**Environmental  
Planning  
Commission**

**Agenda Number: 3  
Project Number: 1007100  
Case #'s: 08EPC-40023  
May 8, 2008**

**Staff Report**

<b>Agent</b>	Planning Department
<b>Applicant</b>	City of Albuquerque
<b>Request</b>	Recommendation of approval of the Great Streets Facility Plan, a Rank 2 Plan
<b>Legal Description</b>	NA
<b>Location</b>	Citywide
<b>Zoning</b>	Not Affected

**Figure 19: Pedestrian Realm**  
(not to scale)

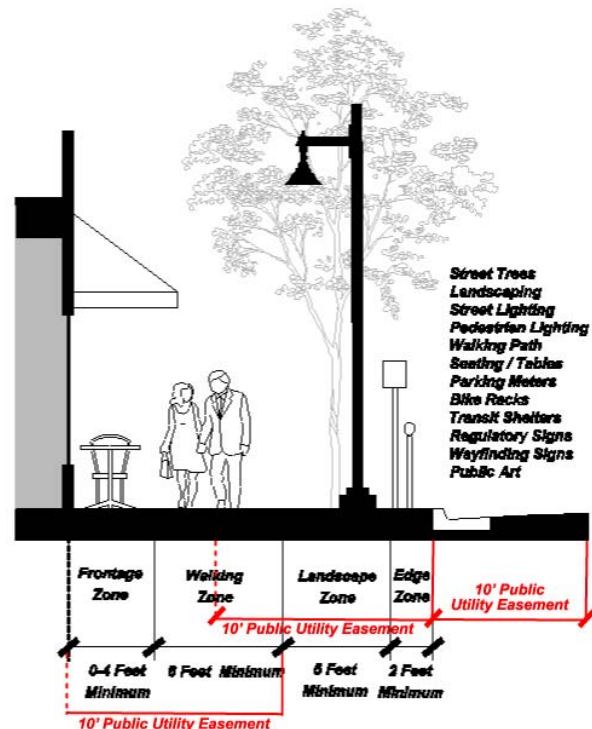
36. Page 33 Revise Figure 19 to show options for the location of PUE’s as shown in this revised illustration. Also use this illustration on page 61 of Part IV, C. Prototype Designs of Great Streets for PUE’s.
